From: Don Seltzer <timoneer@gmail.com>
 To: Rachel Zsembery <rzsembery@town.arlington.ma.us>, KLa@town.arlington.ma.us, Eugene Benson <EBenson@town.arlington.ma.us>, MTintocalis@town.arlington.ma.us, Stephen Revilak <srevilak@town.arlington.ma.us>
 Cc: Claire Ricker <cricker@town.arlington.ma.us>, Kelly Lynema <klynema@town.arlington.ma.us>
 Date: Sat, 21 Jan 2023 11:03:52 -0500
 Subject: Docket 3560 - 190 Mass Ave Ceiling Height issues

To: Arlington Redevelopment Board

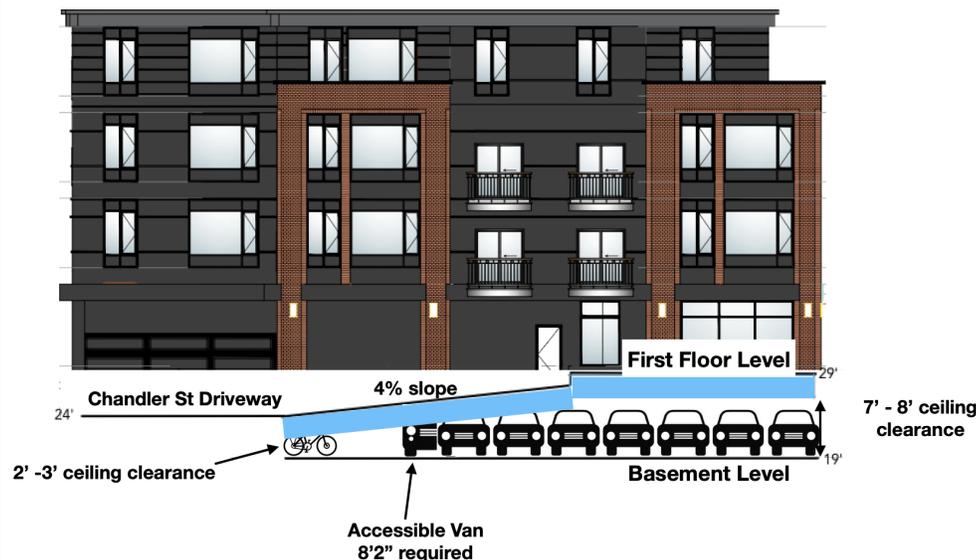
In a previous email I called your attention to the lack of dimensioned elevation views of the proposed building. Since then, the applicant has belatedly added an incomplete set of elevation views to the public hearing package. These drawings omit any useful information regarding the parking garage levels, obscuring the unfortunate lack of sufficient ceiling height. I have drawn up what the limited data suggests about these parking levels.

The first floor retail space is at an elevation of 29', slightly above that of Mass Ave. The terrain is sloped downward along Chandler St with the entrance to the parking garage at an elevation of 24'.

The eight tandem parking spaces at street level are sloped at about 4%. There is an entrance ramp leading to the lower level. It descends at a very steep slope of 13% over a run of about 38', dropping down to the lower level elevation of 19'.

A portion of the below grade parking is at 10' below the first floor elevation. Accounting for ceiling structure, the actual clearance is probably 7' - 8'.

Another portion of the below grade parking is under the sloped tandem parking area, with the height clearance dwindling down to only 2' - 3'. This includes the bicycle storage area, the HP van space, and three of the EV car spaces.

Clearly this is impractical. It is also unacceptable under state law which requires that there be a minimum access route clearance of 8'2" for HP vans.

The change in grade from the 24' elevation Chandler St entrance to the 19' parking level is provided by a short, dangerously steep ramp, 13% grade over approximately 38'. Design standards for such ramps recommend that steep ramps over 10% have transition zones with slopes of half the grade. In this instance, the Chandler St entrance driveway should transition to a ramp of 6.5% with a length of least 8', then the 13% ramp, followed by a second 6.5% transition ramp before reaching the level parking area.

Significant redesign is necessary, and may not even be possible considering the limitations of this property. A 11,000 sf lot is not very big and probably cannot accommodate underground parking with safe ramp access. A similar problem arose with an application for a 16,000 sf lot at 10 Sunnyside that came before this Board several years ago. The underground parking was to be accessed by a dangerous 15% ramp with no transition zones at either the street level sidewalk nor the lower level parking.
